Bullock Creek School District
2024 Bond- Series 2 - 2027 Renovations
HS / MS / Floyd and Pine River Elementary Schools

ADDENDUM #1

Project: No. 26-210 Bullock Creek 2023 Bond Series 2
2027 Improvements

Issue Date: November 2, 2026

SEAL	DRAWN CJV/KLS	PROJECT NO. 26-210
	CHECKED KLS	CAD FILE NO. B-M103
	REVIEWED MLB	DRAWING NO. B-M103
	DATE OCT 19, 2026	SHEET NO. 15 OF 38
	SCALE AS NOTED

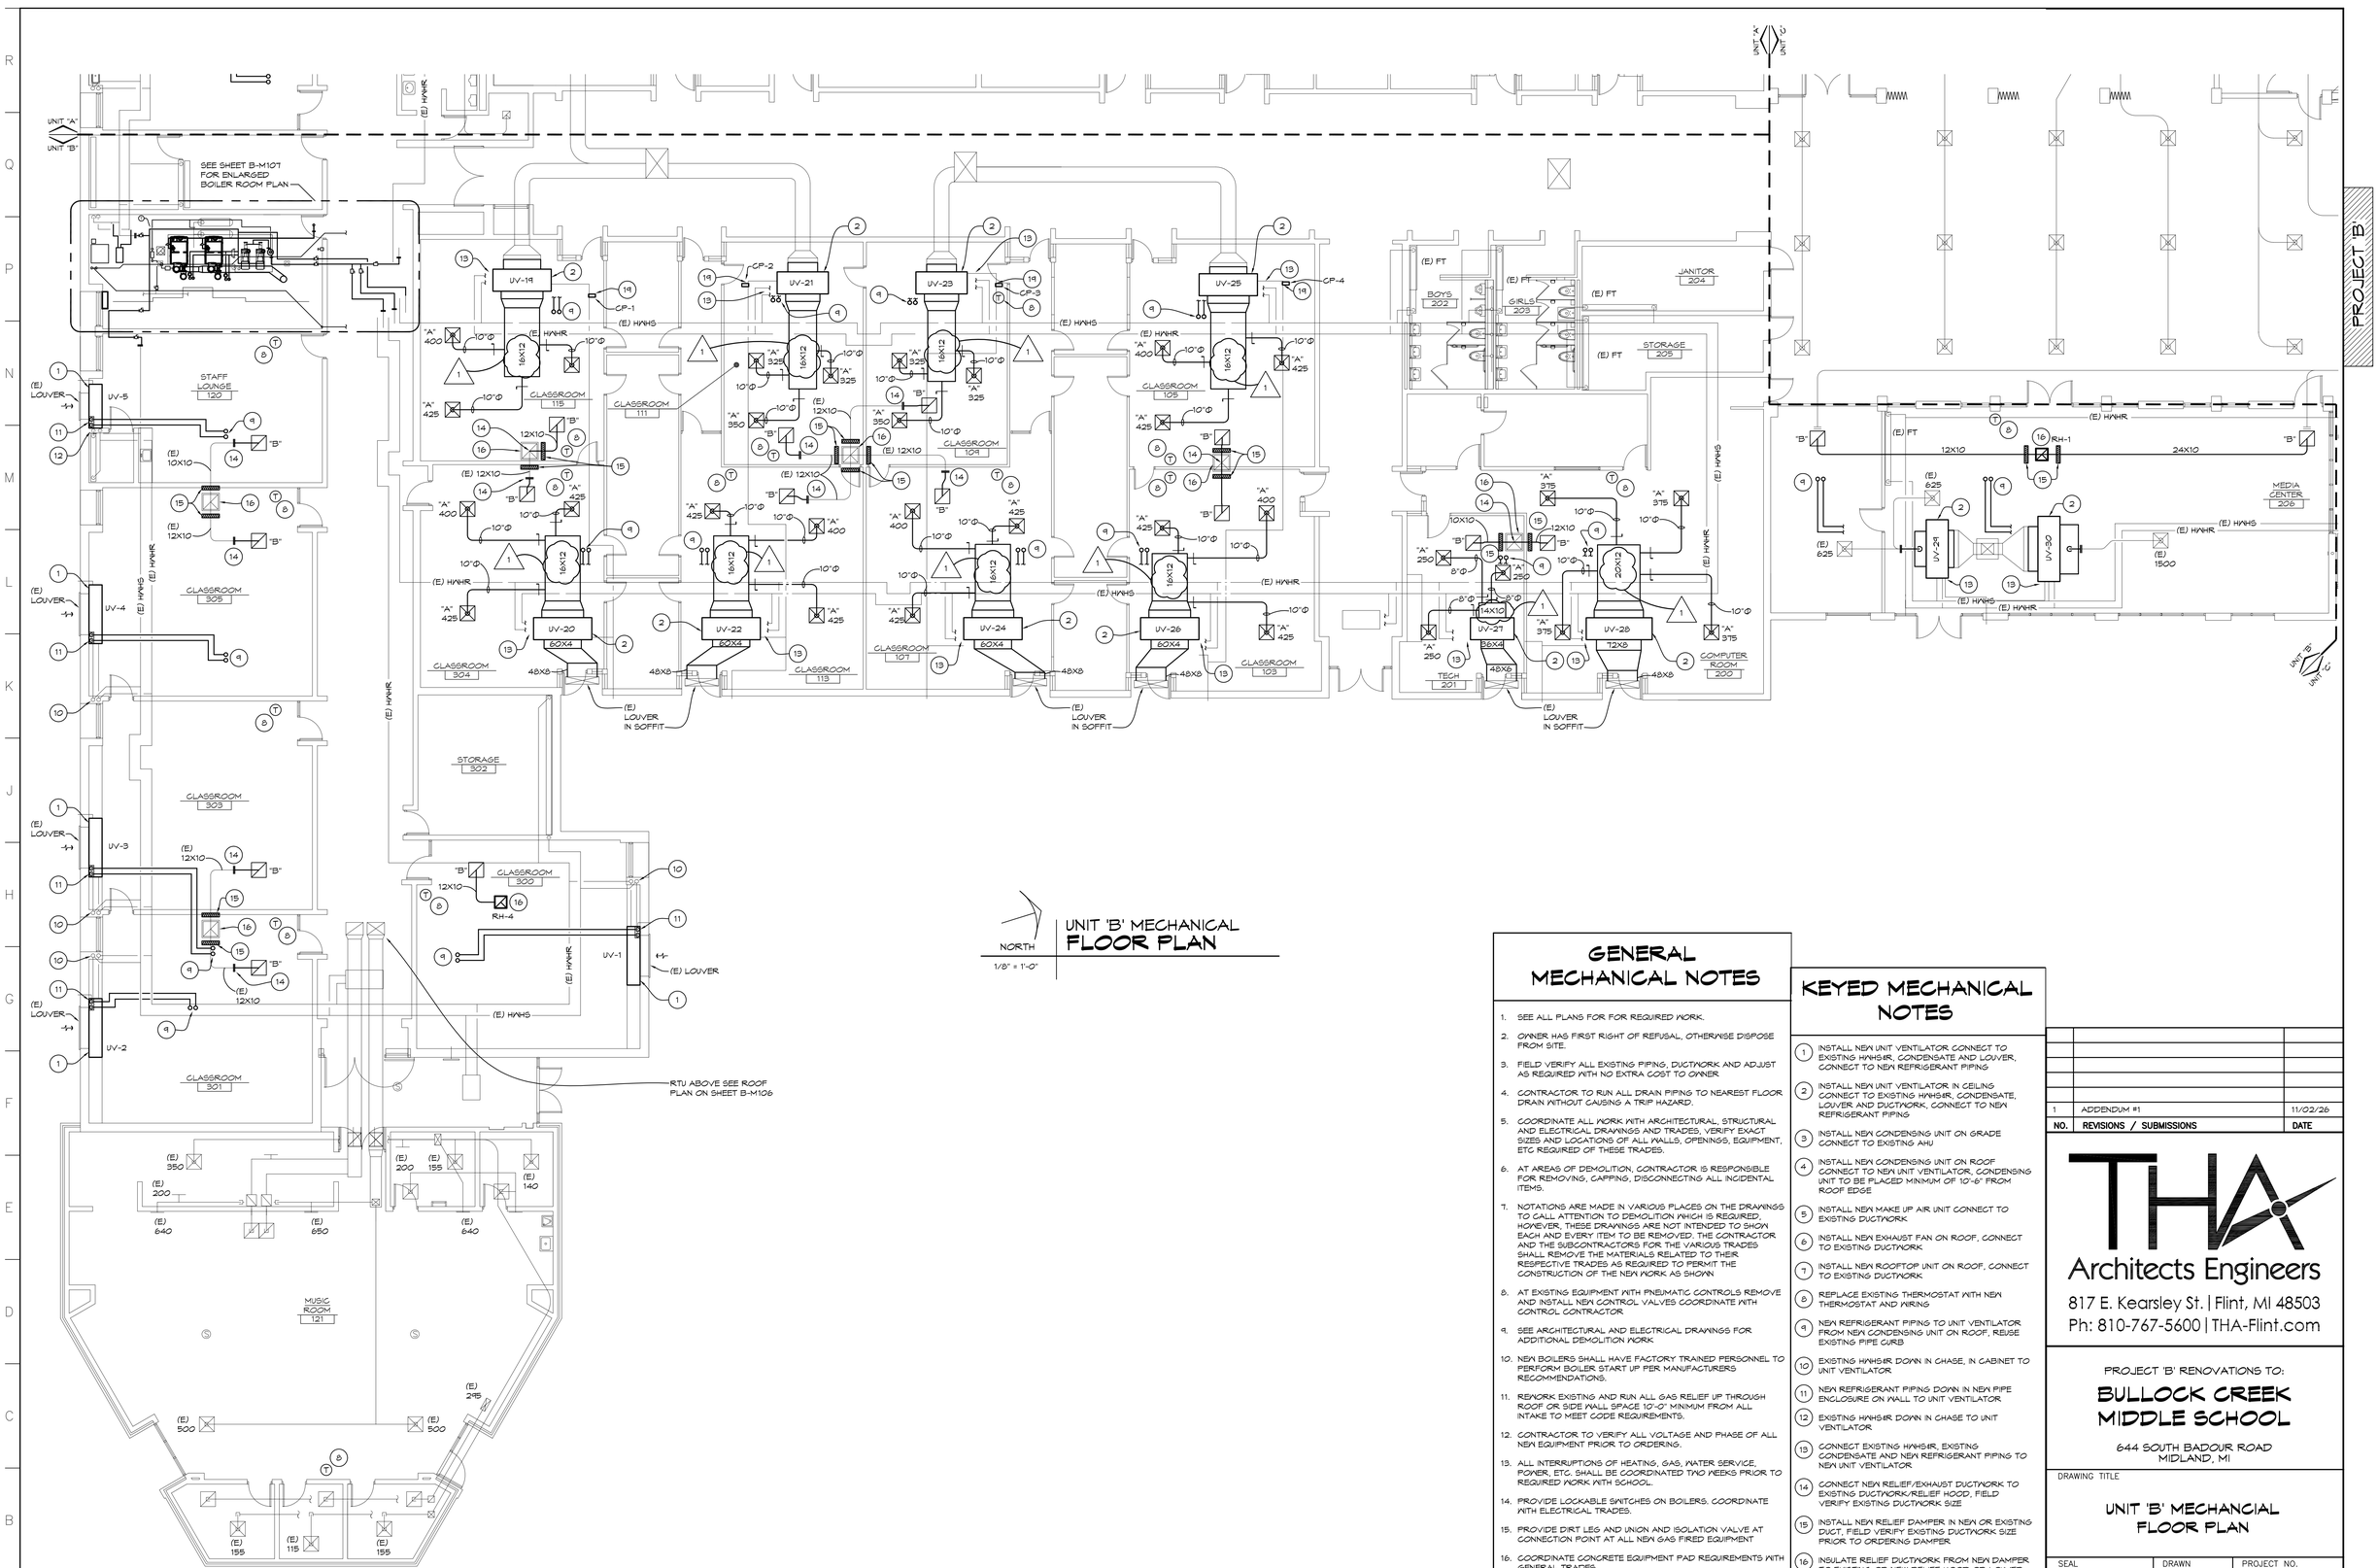
Item #M5: Revise Sheet B-M103 as follows:

a. Duct size and thermostat location added for "UV-13".

SEAL	DRAWN CJV/KLS	PROJECT NO. 26-210
	CHECKED KLS	CAD FILE NO. B-M104
	REVIEWED MLB	DRAWING NO. B-M104
	DATE OCT 19, 2026	SHEET NO. 16 OF 38
	SCALE AS NOTED

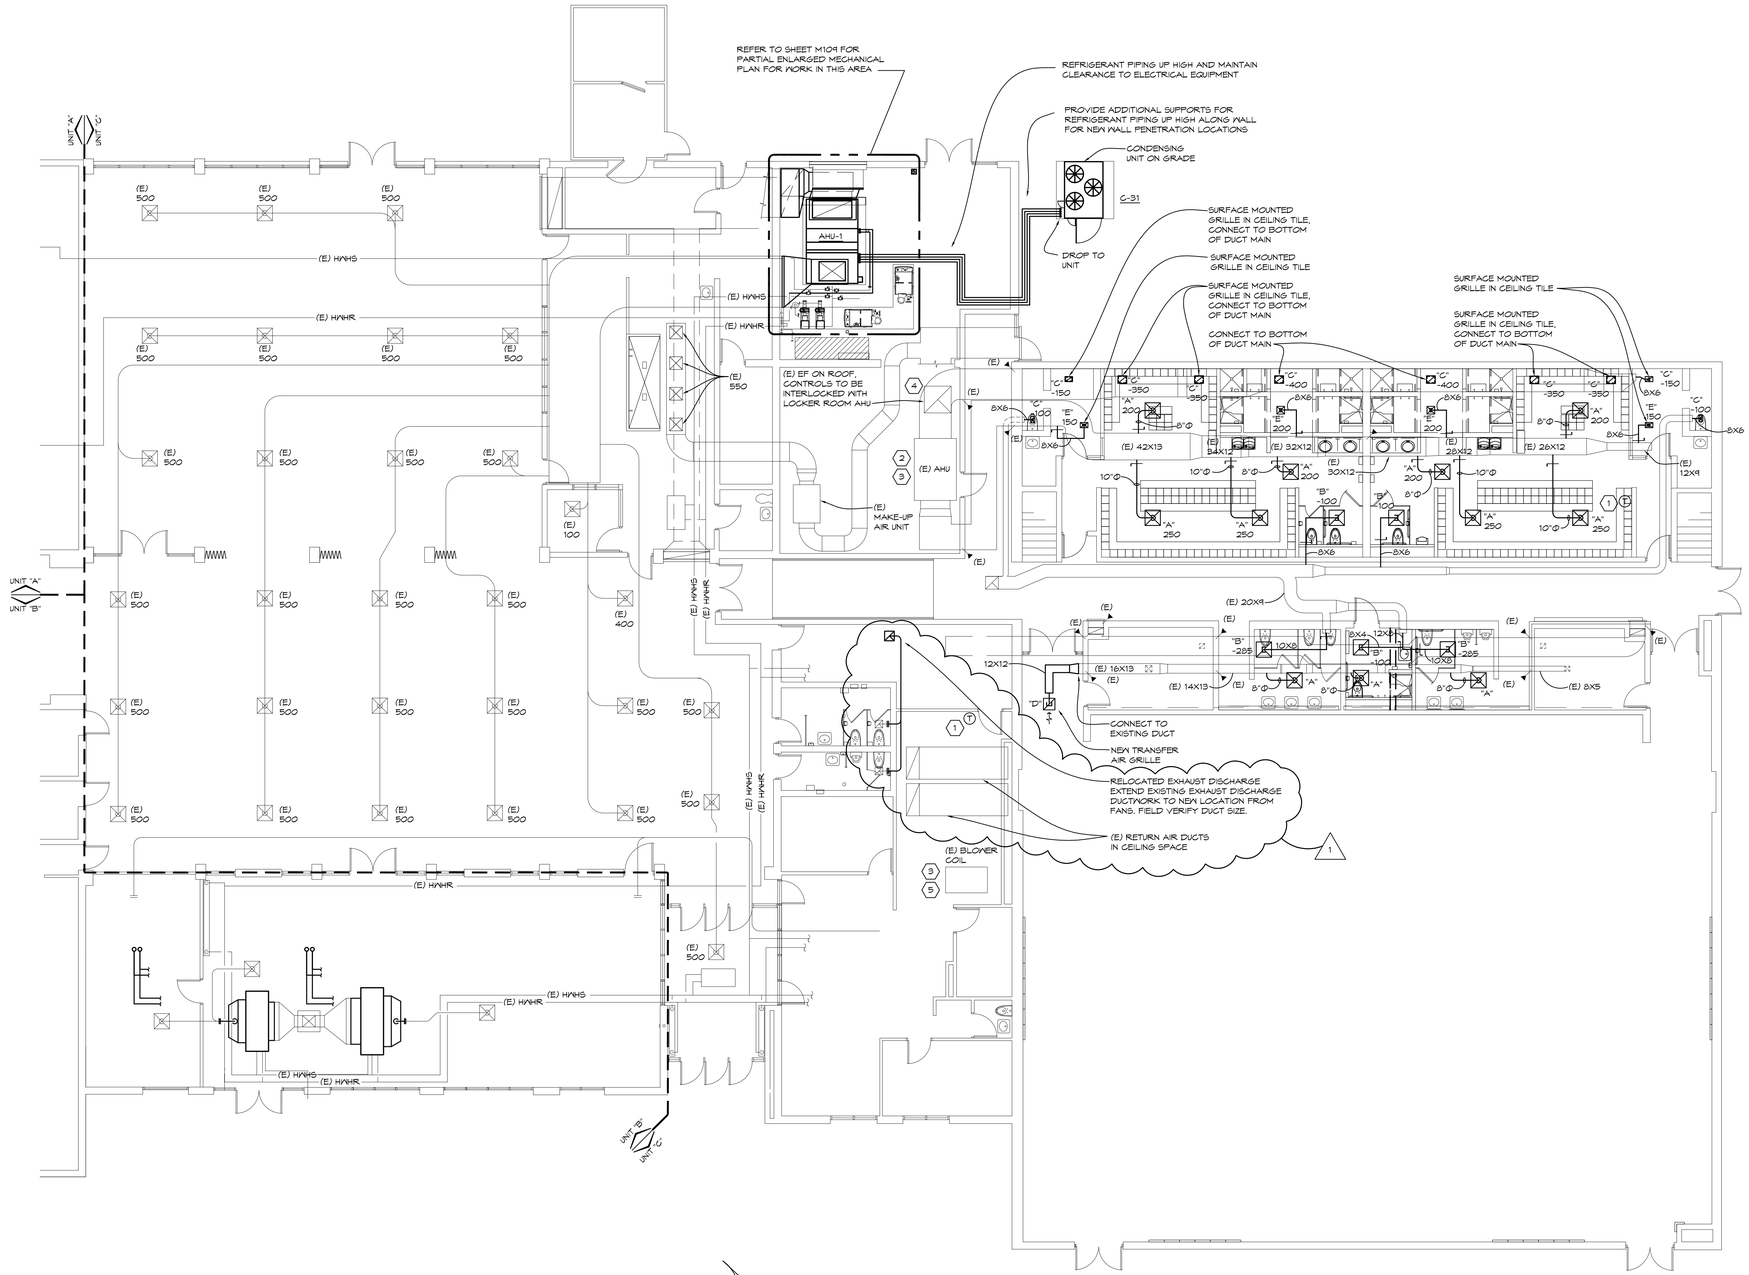
Item #M6: Revise Sheet B-M104 as follows:

a. Duct sizes added for unit ventilators in "Unit B".

SEAL	DRAWN CJV/KLS	PROJECT NO. 26-210
	CHECKED KLS	CAD FILE NO. B-M105
	REVIEWED MLB	DRAWING NO. B-M105
	DATE OCT 19, 2026	SHEET NO. 17 OF 38
	SCALE AS NOTED

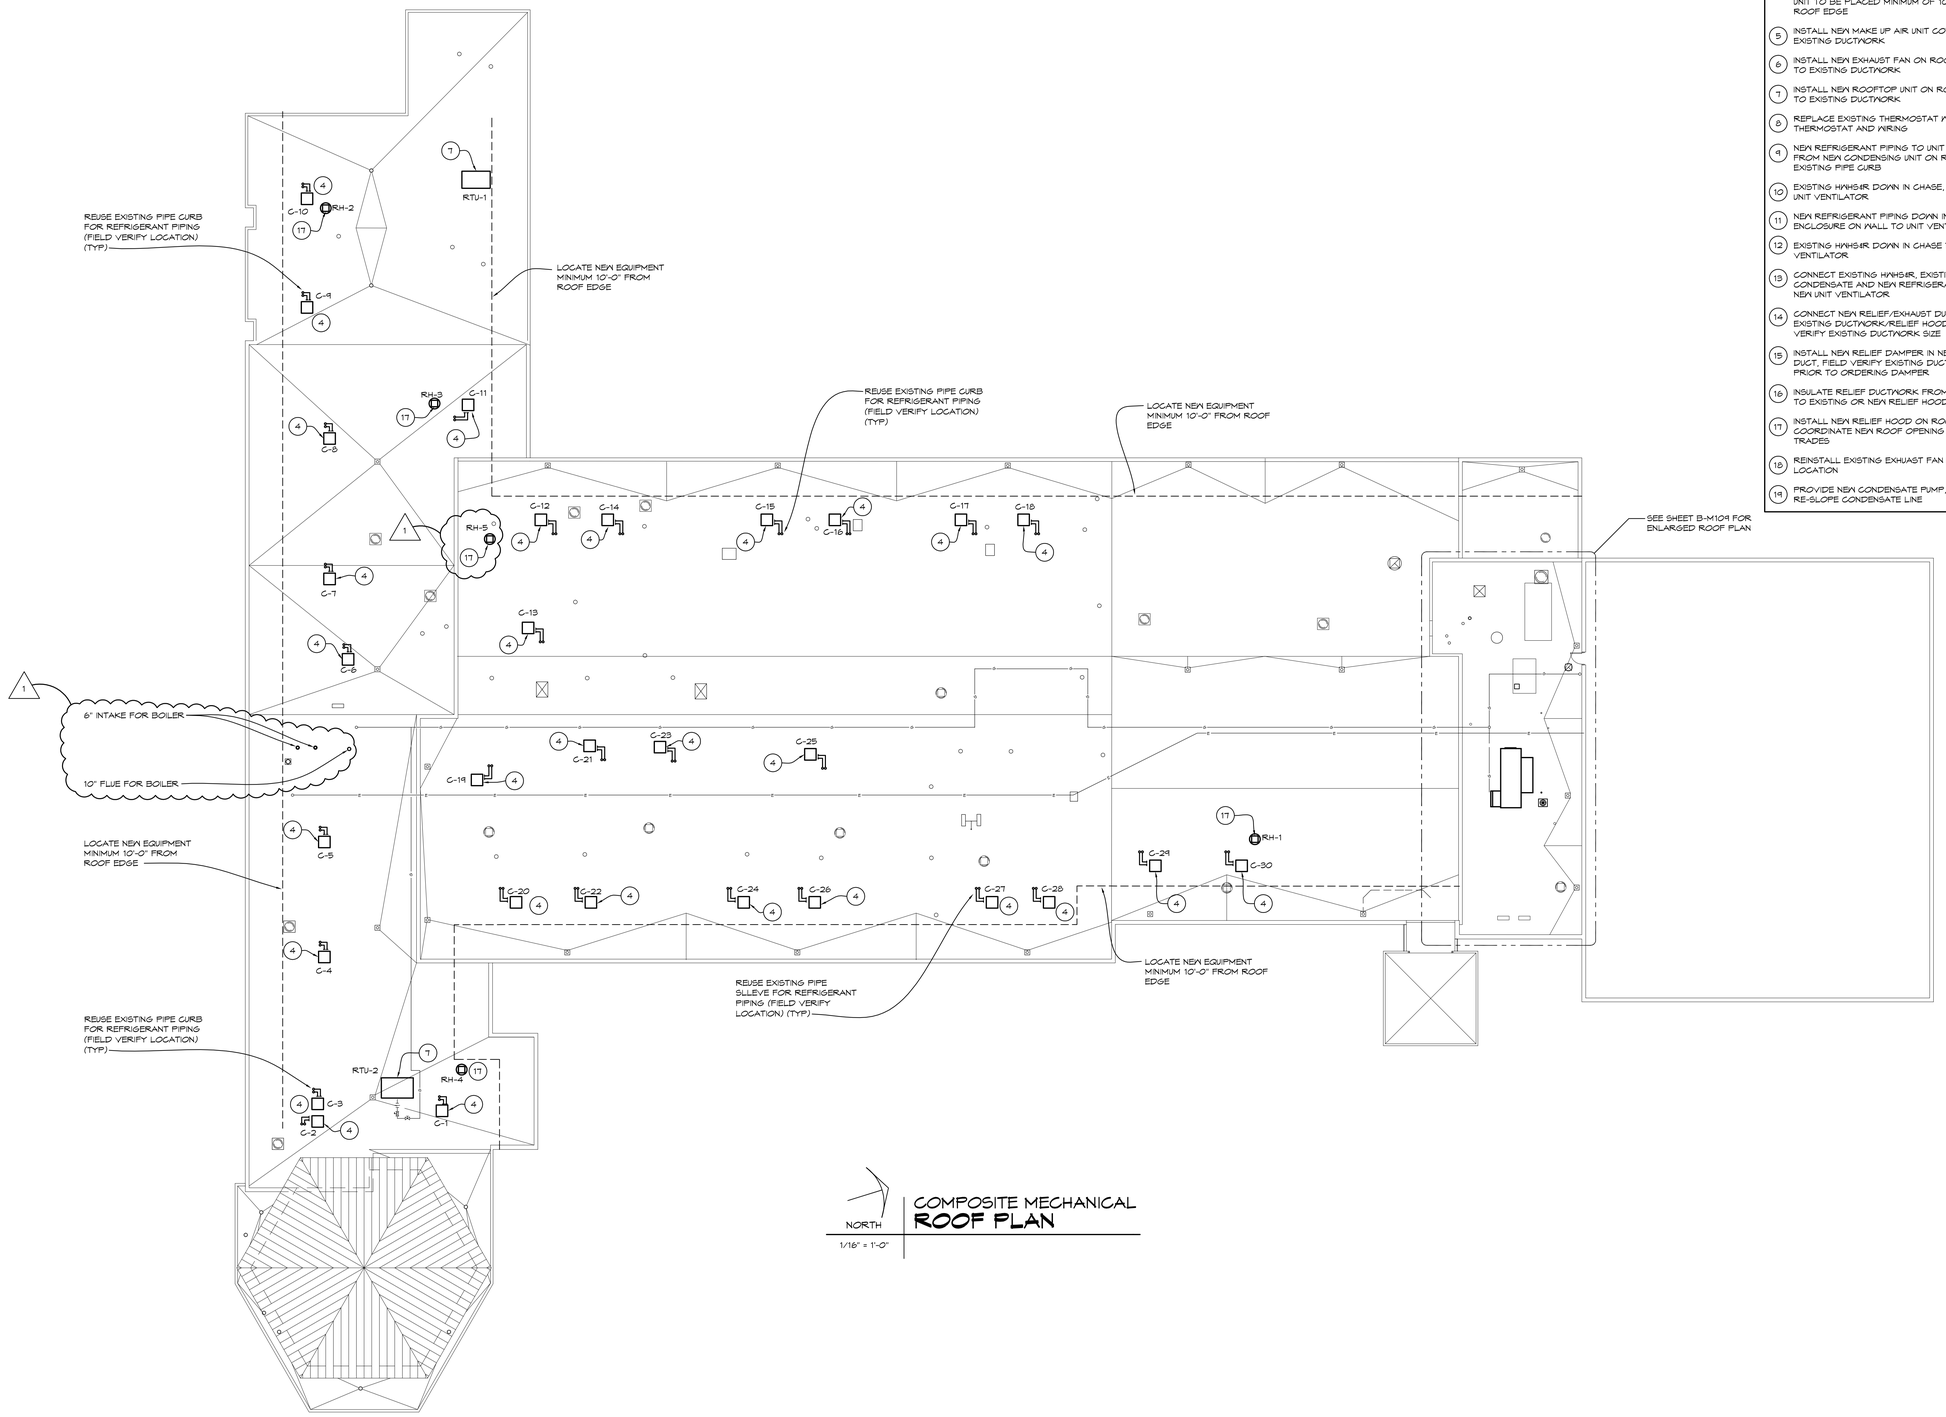
Item #M7: Revise Sheet B-M105 as follows:

a. Ductwork for Toilet Rooms extended for relocated discharge hood shown on B-M109. Return air ducts for Gymnasium shown on Plan.

SEAL	DRAWN CJV/KLS	PROJECT NO. 26-210
	CHECKED KLS	CAD FILE NO. B-M106
	REVIEWED MLB	DRAWING NO. B-M106
	DATE OCT 19, 2026	SHEET NO. 18 OF 38
	SCALE AS NOTED

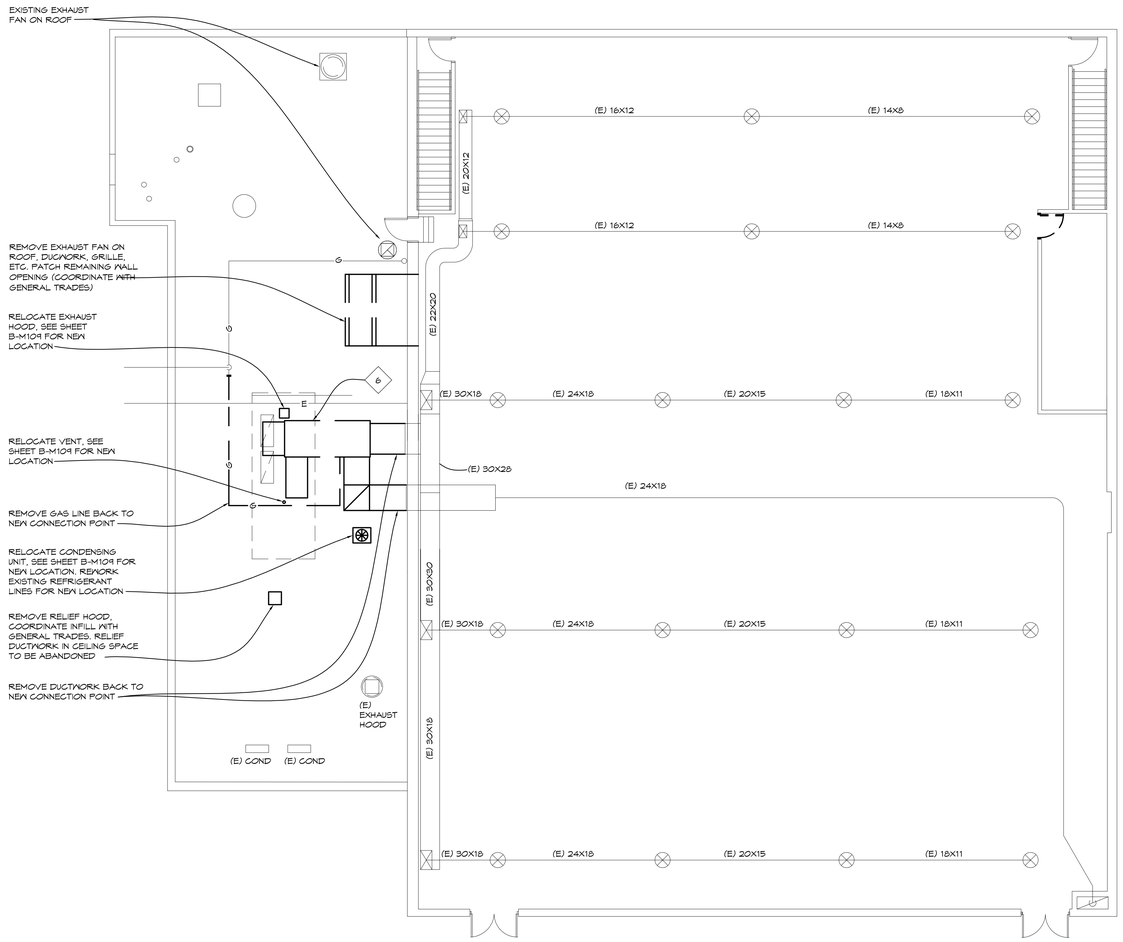
Item #M8: Revise Sheet B-M106 as follows:

a. "RH-5" noted on Roof Plan and Note 17 added to relief hood location.
b. Boiler flue and intakes shown on Roof Plan.
